Stage 02: Industry Consultation

National Electricity Transmission System Security and Quality of Supply Standards (NETS SQSS)

GSR014: Review of Requirement of Onshore Connection Facilities for Offshore Wind Farm Connections: Industry Consultation

Figure 1. Schematic diagram of the offshore transmission system designs considered.

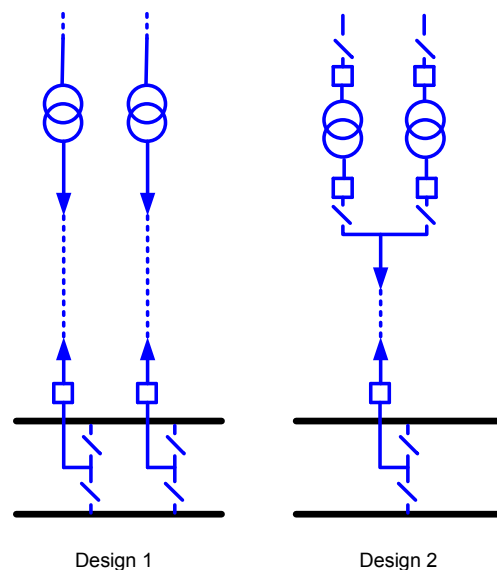
- 1.1 The GSR014 Working-Group has conducted a cost benefit analysis (CBA) using the Spackman¹ approach to determine the optimum design of offshore transmission connections to onshore electricity networks for AC connected offshore generation. Specifically, the CBA considered whether two HV switch-bays (Figure 1 Design 1) or one HV switch-bay (Figure 1 Design 2) should be installed where the offshore wind farm connects to the onshore transmission network.
- 1.2 For the purpose of this analysis it was assumed that the onshore elements for the connection of the offshore transmission system, for which schematic diagrams are presented in Figure 1 below, would operate at 400kV. Furthermore, such systems shall comprise of underground cables, circuit breakers, disconnectors, transformers and the onshore substation that connects the offshore system to the onshore system.

- 1.8 The Spackman approach was used to compare the costs and benefits between Design 1 and Design 2, both shown in Figure 1 above.
 - The capital costs used were the transmission investment costs of each design. The transmission capital costs were converted into an annual cost using the IDC value of 7.9%. This produces a stream of financing costs or an appropriate time profile of annualised costs.

- 1.9 The results show that using the Spackman approach, Design 1 gives a higher NPV benefit compared to Design 2 when tested over a range of generation capacities for both AIS and GIS switchgear designs.

- 2.6 Therefore the aim of this study was to investigate whether the current implied requirement for two transformers and two high voltage substation bays where offshore cables connect to the onshore network is justified or whether two transformers connected to a cable and a single bay would be sufficient.

- 2.7 The GSR014 Working-Group investigation didn't show that the single bay option was economic. In fact, there was a firm cost benefit case for Design 1 (i.e. two bays). The proposed change to the NETS SQSS will make the use of Design 1 clearer. In practice the vast majority of offshore designs have adopted this two bay approach already. The proposed NETS SQSS changes will formalise the position.

7.13.1.1 *With effect from 31st December 2014, in the case of new offshore power park module only connections, and where the offshore grid entry point capacity is 120MW or more, following a planned outage or a fault outage of a single AC offshore ~~transformer~~ transmission circuit at the onshore AC transformation facilities or between the onshore AC transformation facilities and the Onshore Transmission System, the loss of power infeed shall not exceed the smaller of either: 50% of the offshore grid entry point capacity; or the full normal infeed loss risk. (For the avoidance of doubt, connection offers signed by all parties before 31st December 2014 for connections which are configured with two AC transformers banked onto a single 400kV or 275kV switch-bay are deemed to be compliant with Section 7.13.1.1.)*
